**NOTICE OF A REGULAR MEETING
BONDURANT PLANNING AND ZONING COMMISSION
FEBRUARY 8, 2024**

TITLE: Resolution PZ-240208-03 - Resolution considering site plan for Bondurant-Farrar Community School District High School Arts Addition at 1000 Grant Street North.

EXISTING SITE SURVEY

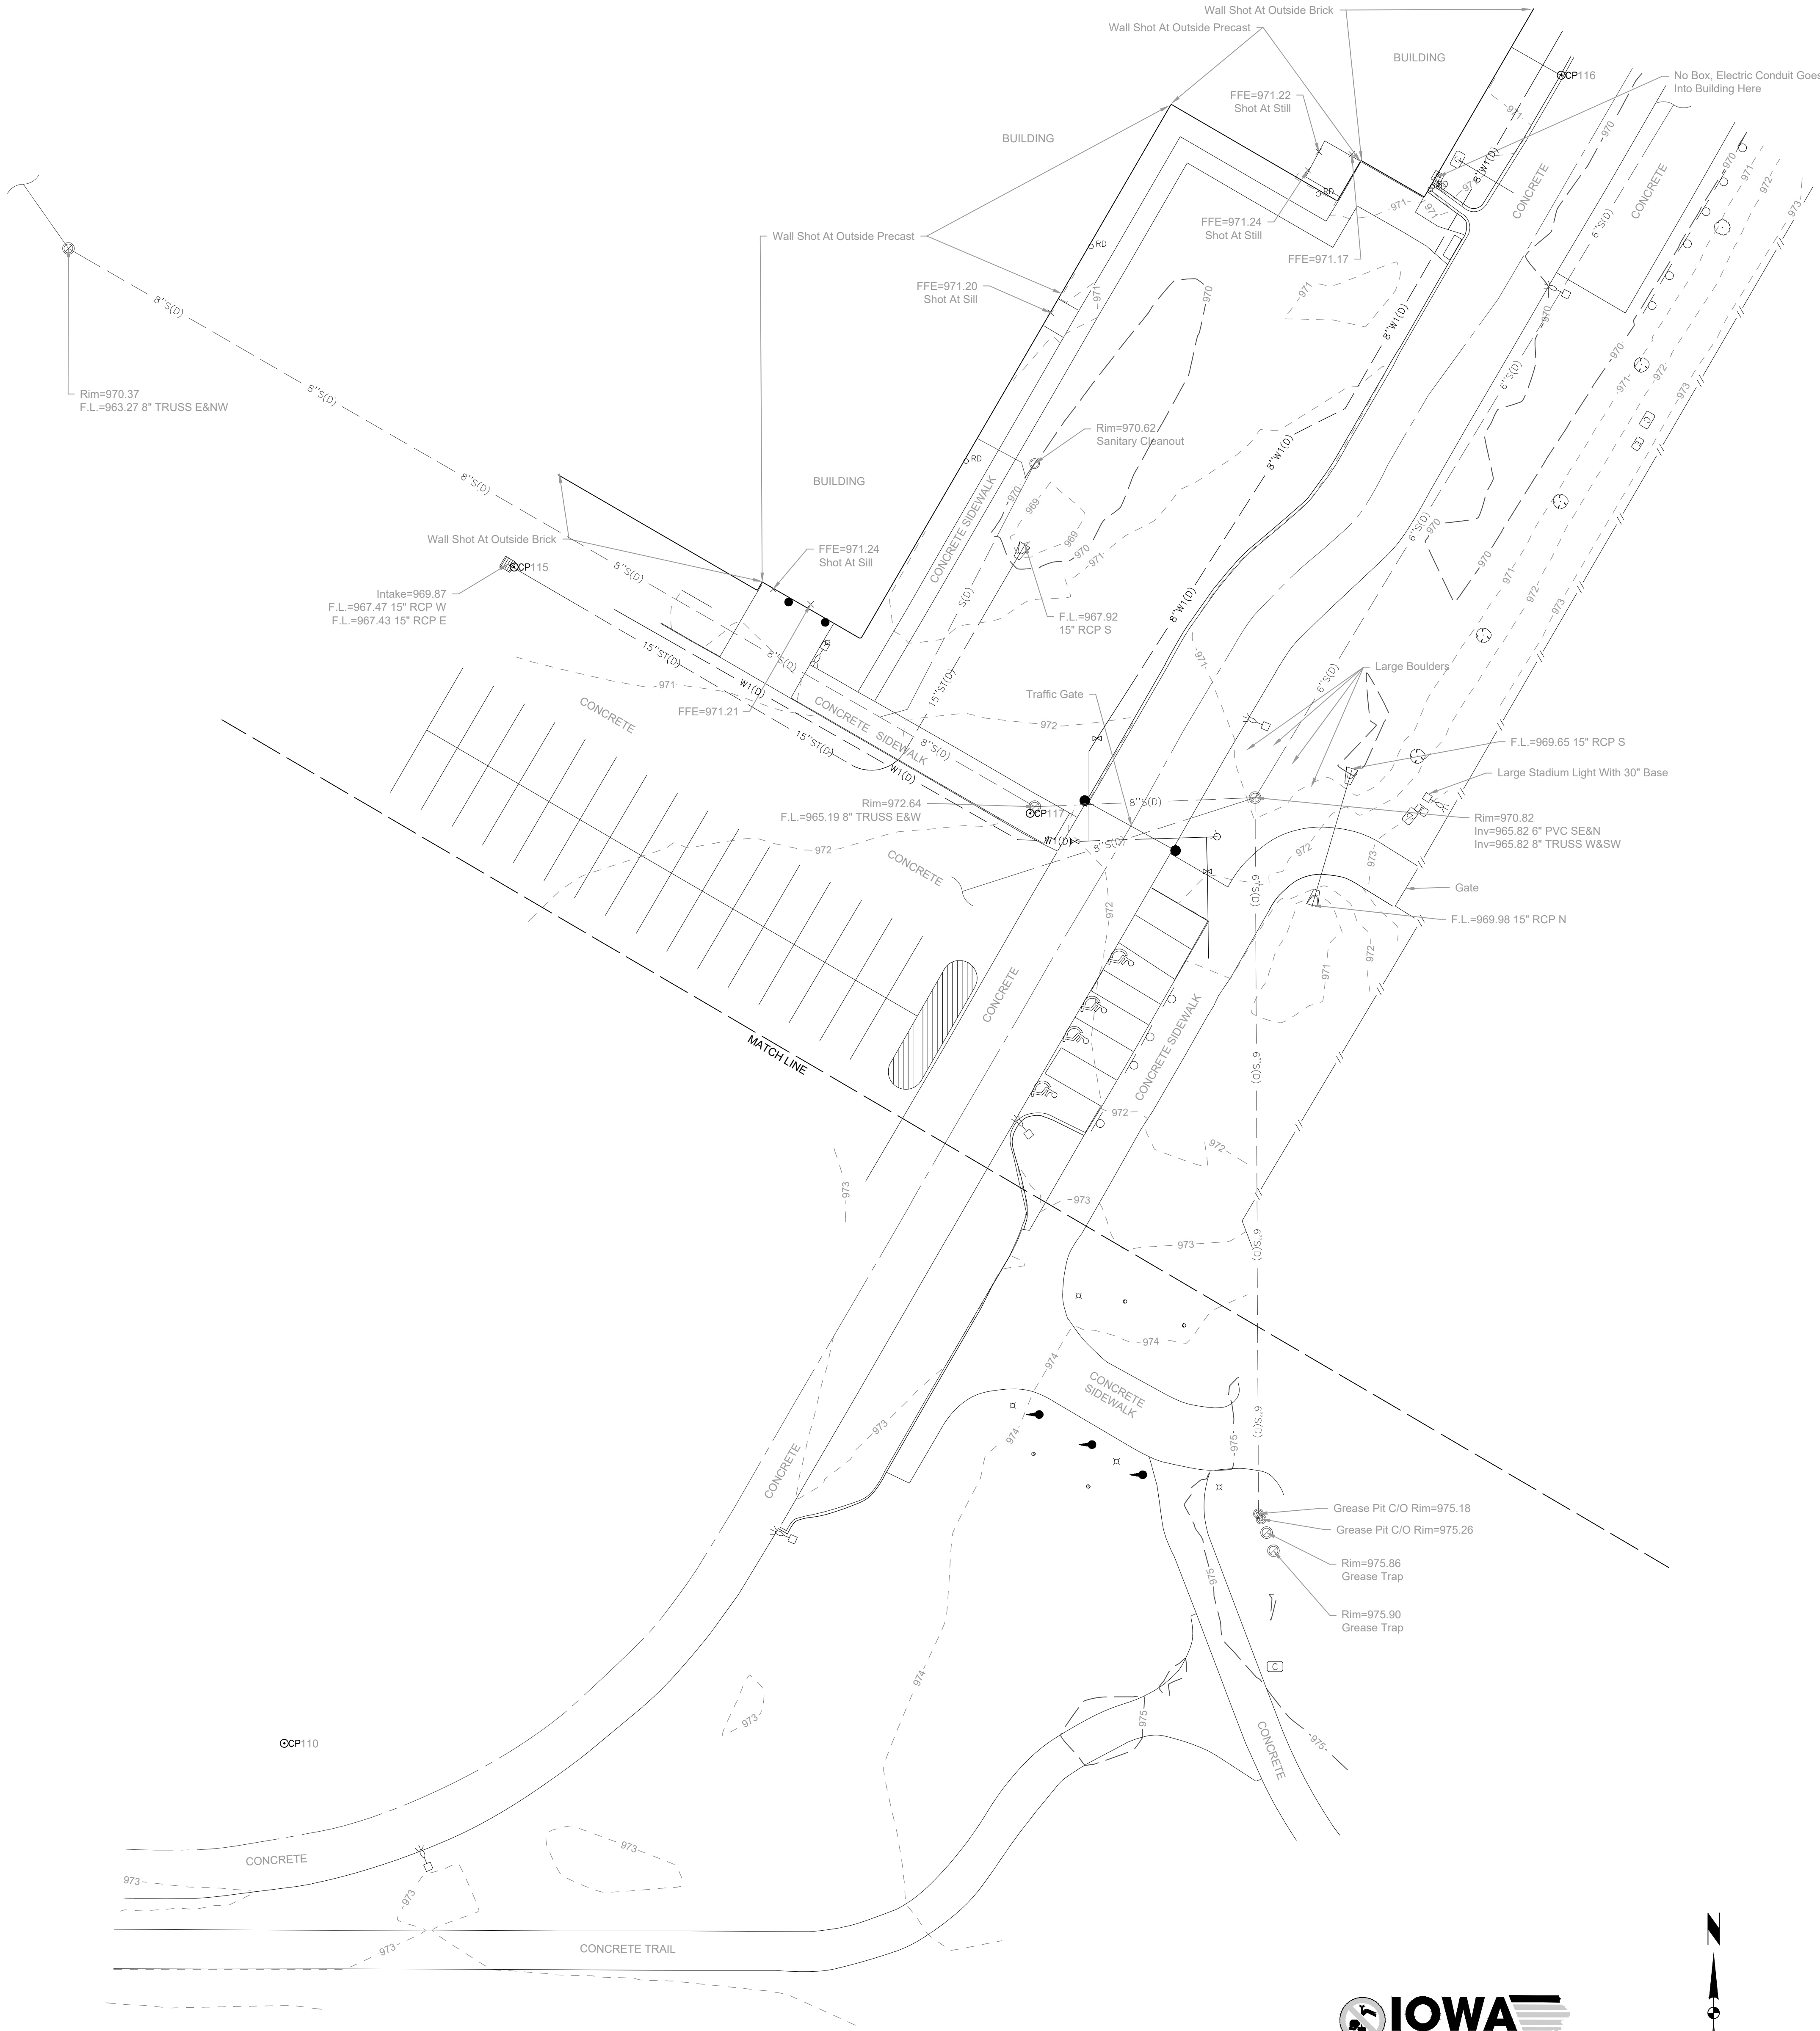
- The required setbacks at this location - a 50' front yard setback, a 50' rear yard setback and a 50' side yard setback.
- The submitted site plan currently shows setback requirements for A-1 Agricultural District. The proposed school addition meets the required 50' setbacks from all property lines, but need to be reflected on the site plan before approval by City Council.

LANDSCAPE PLAN CONSTRUCTION NOTES

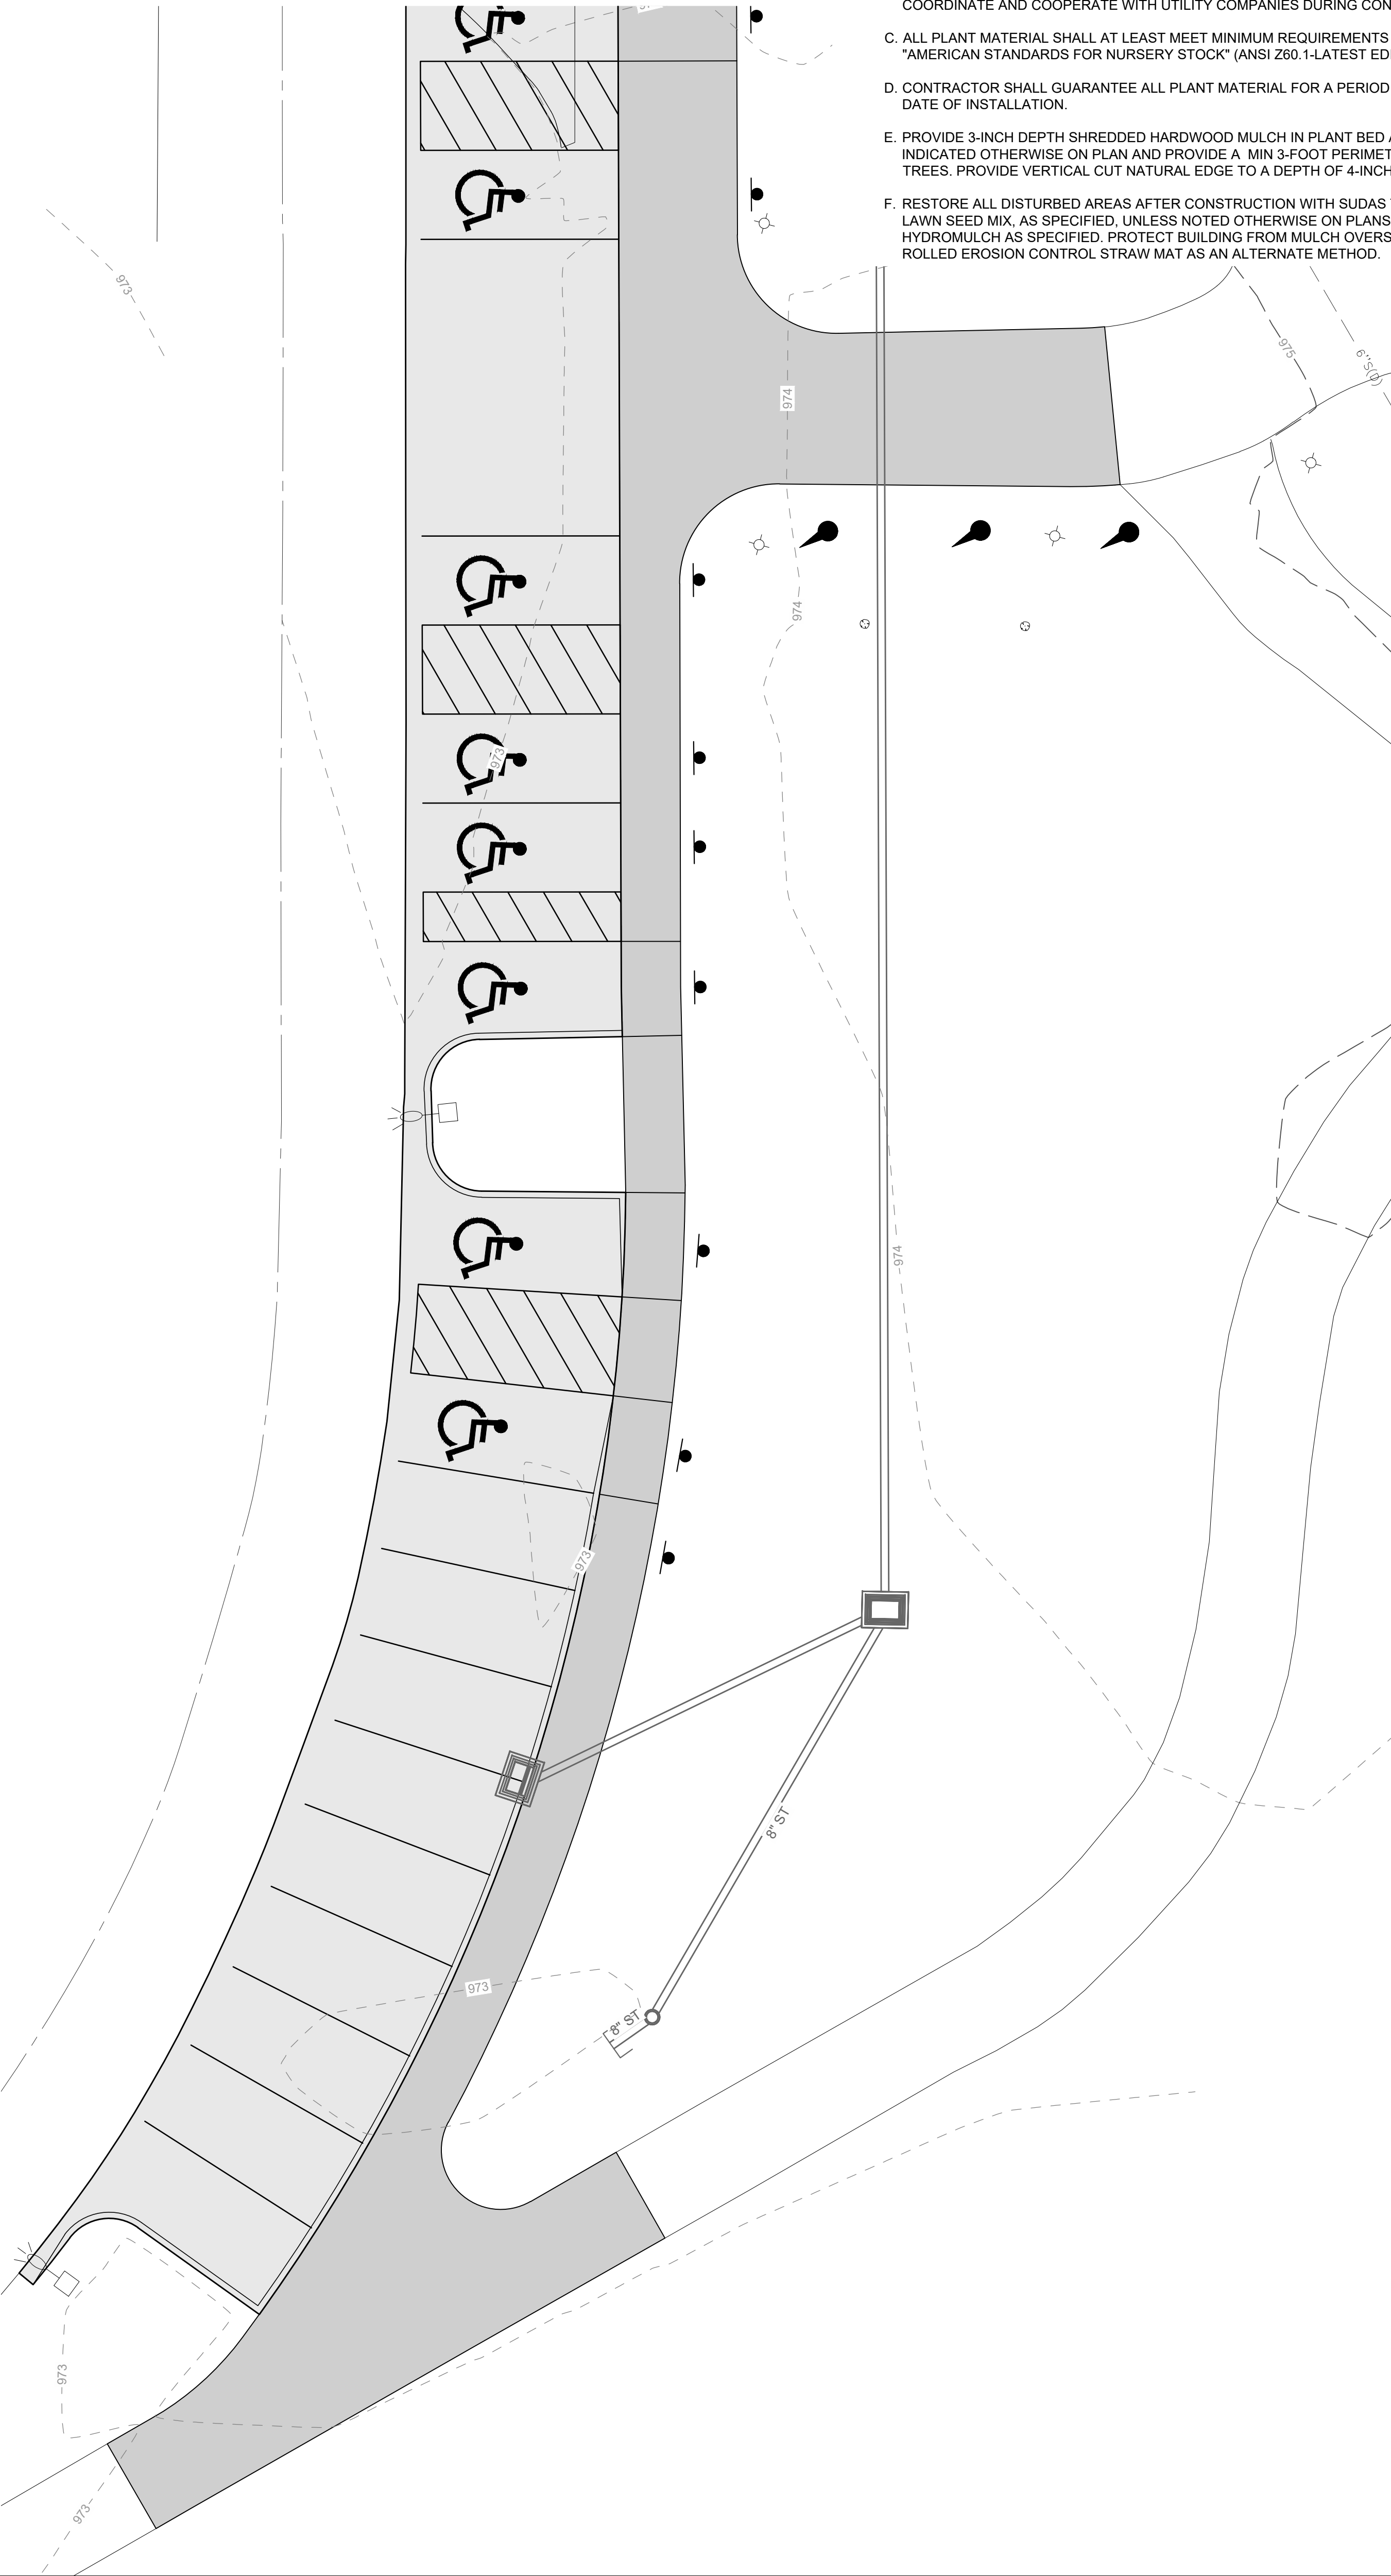
- A previous landscaping plan has been approved for this site, resulting in no additional landscaping being required. However, the applicant is proposing the installation of 13 shrubs, more detailed can be found on page 7 of the attached site plan.
